UNITED STATES PATENT AND TRADEMARK OFFICE

10/764,071

Office Action Summary

THIS FINAL ACTION IS RESPONSIVE TO THE AMENDMENT FILED 10/9/2007.

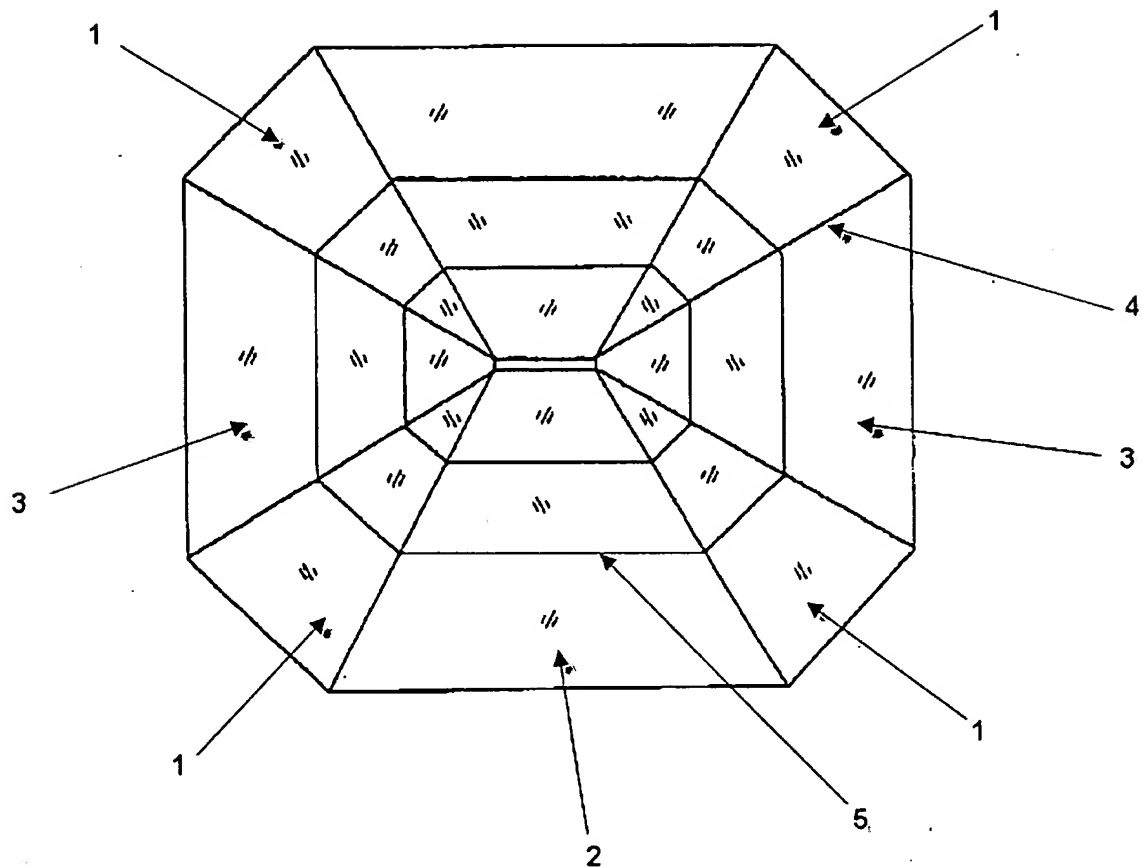
As for Claim 1, Abaev teaches of a mixed cut gemstone comprising:

a brilliant cut crown;

a step cut pavilion (see figure below);

four lower corner facets (1), said lower corner facets being triangles (1);

two long-side lower girdle facets (2), said long-side lower girdle facets being triangles or trapezoids (2);

two short-side lower girdle facets (3), said short-side lower girdle facets being triangles (3);

a plurality of step cuts (5), said step cuts being substantially equal in width; and

a plurality of rib lines (4);

whereby said step cuts (5) are cut at a predetermined angle with respect to said lower girdle facets (2,3) with each step (5) being at a slightly different angle, said different angle step cuts (5) [allowing light that passes through the crown to hit the plurality of step cuts at different angles thereby bending the light several times in different directions thus providing the gemstone with parallel incoming and outgoing rays of light that make the gemstone appear more brilliant and scintillated].
